Postulated Initiating Events for the IMSR400

Topical Report

Revision B

Figure 2: Plant operating modes and the transitions between them for normal operation¹

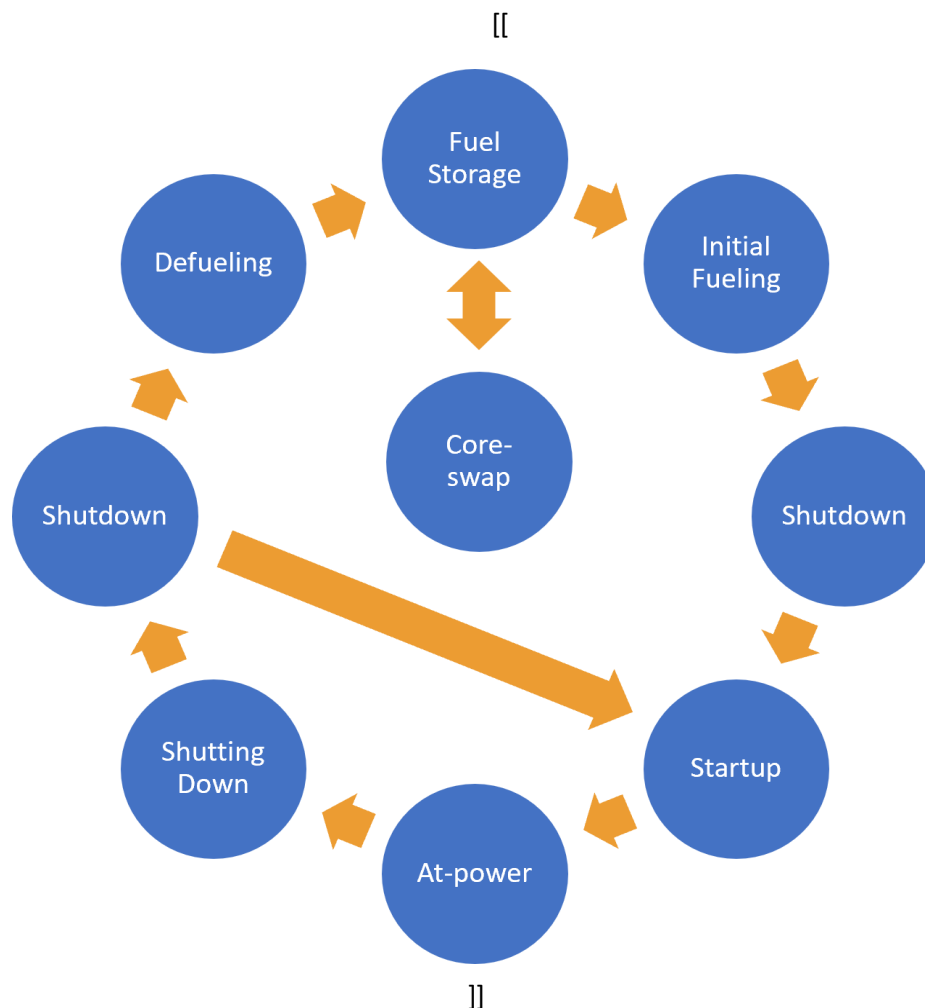
Joint Feedback Comment #5

“However, as part of future submittals, regulatory staff expect Terrestrial to provide a clear definition of the top event in the “top-down” approach, and to describe the proposed “top-down” and “bottom-up” approaches in detail. Terrestrial is also expected to describe the process used to integrate the results of both approaches; key assumptions used in the methodology, and explain how they complement each other. “

The top event used in the ‘top-down’ approach is listed in Figure 2. Simply, the top event is the prevention or mitigation of a radionuclide release. The top event is consistent with the most significant safety function performed by the IMSR400.
